FINAL PLAT

REGENCY LAKES COMMERCIAL ADDITION

RE: S/D 9898 - One-Step Final Plat of REGENCY LAKES COMMERCIAL ADDITION

STAFF REPORT
(One-Step Final Plat Approved 10/22/98)

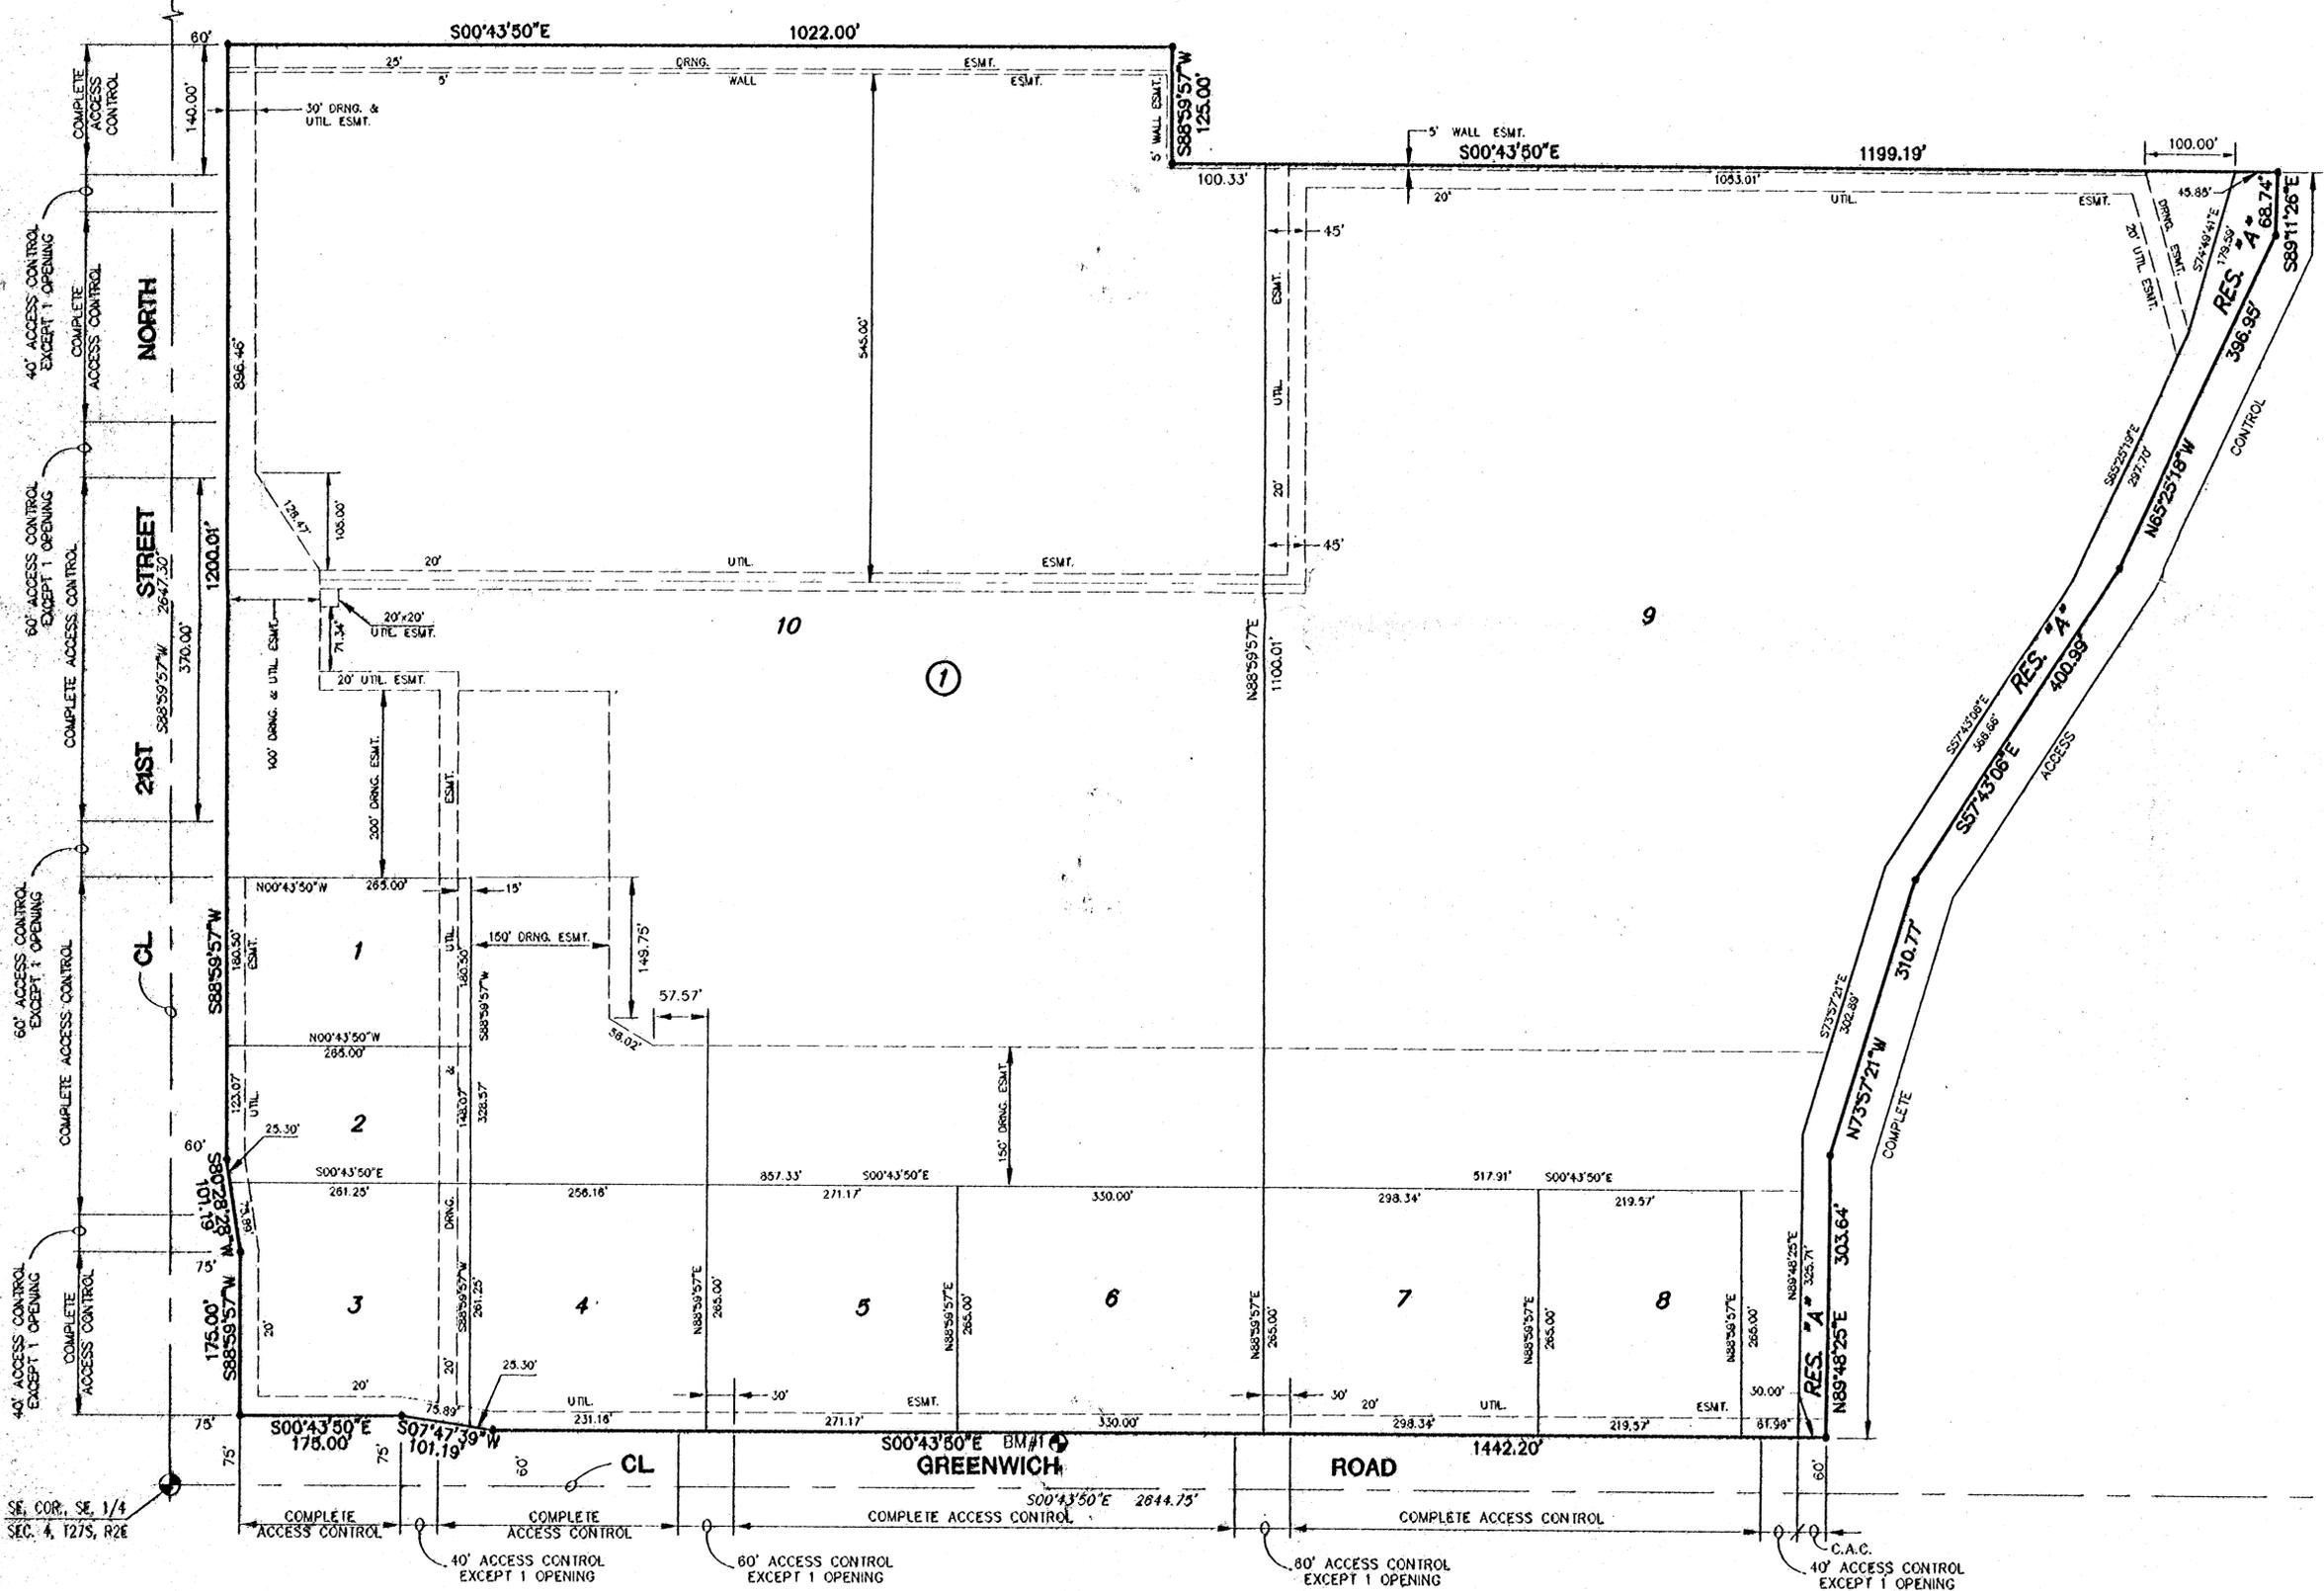
- A. Existing municipal services appear to be available to serve this site. **City Engineering** needs to verify if any guarantees or easements are required. **A guarantee for the extension and relocation of sanitary sewer is required.**

- C. **City Engineering** needs to comment on the status of the applicant's drainage plan. **The drainage plan is approved. A drainage guarantee will be required.**

- D. In accordance with the CUP, a 5-ft wall easement needs to be platted along the west line of the plat, and shall be referenced in the plat's text.
- E. **Traffic Engineering** needs to comment on the need for improvements to 21st St. North and/or Greenwich. **An accel/decel lane along Greenwich will be required. The Applicant is requested to contact the developer of the Manhattan Addition to the east regarding participation in the petition for a center left-turn lane.**

- F. In accordance with the CUP, Reserve A adjoining K-96 is required to be eliminated from the CUP. This portion of the site, proposed for K-96 interchange

improvements, shall not be included within the plat's boundaries, and associated plat's text language needs to be removed.

H. **Traffic Engineering** needs to comment on the access controls. The CUP was approved with four points of access to 21st St. North and five to Greenwich Road. The plat denotes an additional access opening on Lot 2 along 21st St. North. The language in the plat's text regarding access to 21st St. North needs to correctly reference "Block 1". *The number of access openings approved in the CUP are also approved for this plat. One opening along 21st St. North will need to be eliminated.*

I. The Chairman of the MAPC needs to be revised to read, "William M. Johnson".

K. The tie points shall reference section "27S".

M. On the final plat tracing, a note shall be placed on the face of the plat indicating that this Addition is subject to the conditions of the Community Unit Plan DP-234.

O. The centerline of adjoining streets shall be indicated by "CL".

P. The plat's text shall properly reference "K.S.A. 12-512(b)".
